Title: **PRELIMINARY DESIGN STAGE QUALITY AUDIT**  
**For;**  
**Leydens Wholesalers & Distributors Dublin, No. 158A**  
**Richmond Road**

Client: **DBFL Consulting Engineers**

Date: **February 2023**

Report reference: **1754R01**

### Problem S1 – No Tactile Paving at uncontrolled crossing

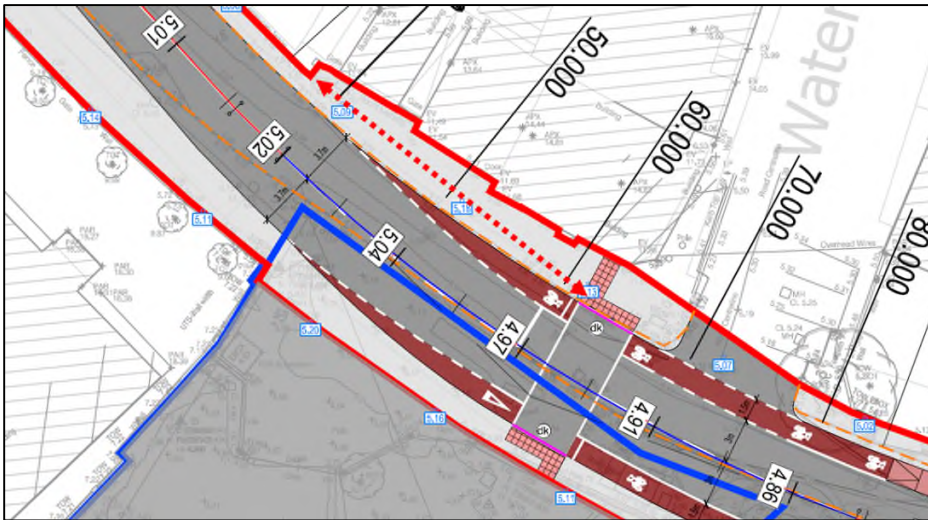
It is proposed to provide a signalised pedestrian crossing to bring pedestrians across Richmond Avenue to the continuous footpath on the northern side. There is however no tactile paving and only partially dropped kerbs at the crossing at the mouth of Waterfall Avenue. This could lead to blind or partially sighted pedestrians not realising that there is a hazard ahead and they may inadvertently stray into the Richmond Road carriageway where they would be at greater risk of being struck by a passing vehicle.

<b>S1</b>	Yes	Yes		
<b>S2</b>	Yes	Yes		
<b>S3</b>	Yes	No	The scheme presented in the submitted development proposals is an interim tie-in (between existing street alignment and improvement works by applicant across its site frontage) until such time that DCC implements its works as part of the Richmond Road corridor enhancements. This existing footpath at its narrowest section is 1.3m wide. Due to third party boundary constraints to the north AND south of the Richmond Rd corridor it has not been possible for the applicant to widen this specific off-site section of the northern footpath without narrowing the southern footpath to less than the 2.0m wide (at this narrowest point at Deakin Court). The southern footpath experiences the larger number of pedestrian traffic in addition to it leading to a new active travel connection to/from the proposed Tolka River Greenway (along the eastern boundary of Deakin Court as part of a separate SHD application on the adjoining Phase 1 plot). It is subsequently considered a greater priority to retain the 2m width at the southern footpaths pinch point (adjoining position of	<b>Yes</b>

### Problem S3 – Insufficient width of Proposed Footpath

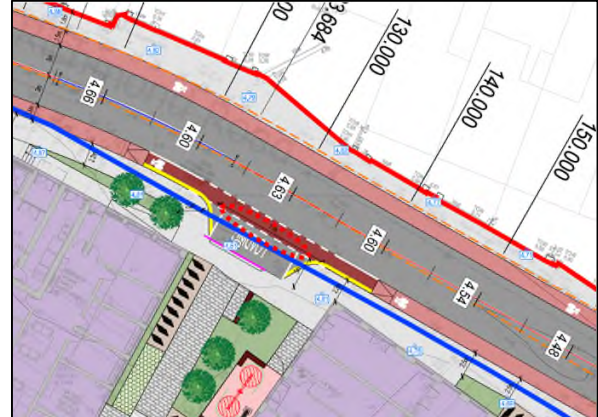
The width of the proposed footpath at the pinch north of the proposed signalised crossing appears quite tight. There were no legible dimensions for auditors to decipher the minimum width proposed. If the footpath width is less than 1.8m, it could lead to pedestrians experiencing difficulty when two people pass each other, particularly for wheelchair users and with buggies.

The designers should ensure that an appropriate footway width in accordance with (i) the requirements of DMURS and (ii) the anticipate pedestrian volumes is provided.

To be Completed By Designer				To be Completed by Audit Team Leader
			proposed active travel link to Tolka Greenway) than in the short term increase the width of the 1.3m wide northern footpath. The northern footpath will be widened at the time when the local authority is advancing its own proposals (identified as a specific roads objective in the DCC Development Plan) for the Richmond Road enhancement works beyond that being delivered by the subject development proposals. The local authority will be made away of the auditors concerns thereby informing the design of the Richmond Road enhancement works being delivered by DCC in the future.	
<b>S4</b>	Yes	Yes		
<b>S5</b>	Yes	No	The internal ground floor level of proposed development is being designed at a higher level to the existing road carriageway in part in response to long term flooding events of the adjoining Tolka River. Whilst pedestrian steps are proposed to the west of the Block A entrance / exit point an alternative route incorporating a ramp of appropriate gradient and width is provided to the east of the buildings entrance / exit point to accommodate the access requirements of mobility impaired users. The replacement of the proposed steps with a second ramp treatment is not possible without adversely impacting upon the width of the 'public' footpath which is to be adopted and managed by the local authority.	<b>Yes</b>

#### Problem S5 – Steps on pedestrian links

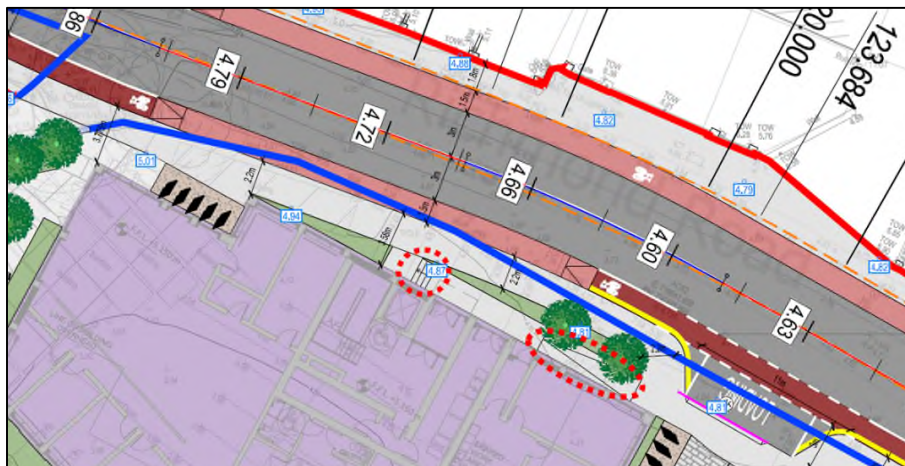
It is unclear to the auditors what the proposed levels for the pedestrian links to the proposed development are to be. It appears that steps are proposed at a pedestrian access to the development, which may limit its use by mobility impaired users. Mobility impaired users may have a longer journey to reach their homes depending on their origin.

It is recommended that pedestrian links without steps be provided throughout the scheme to cater for all users (particularly mobility impaired users).
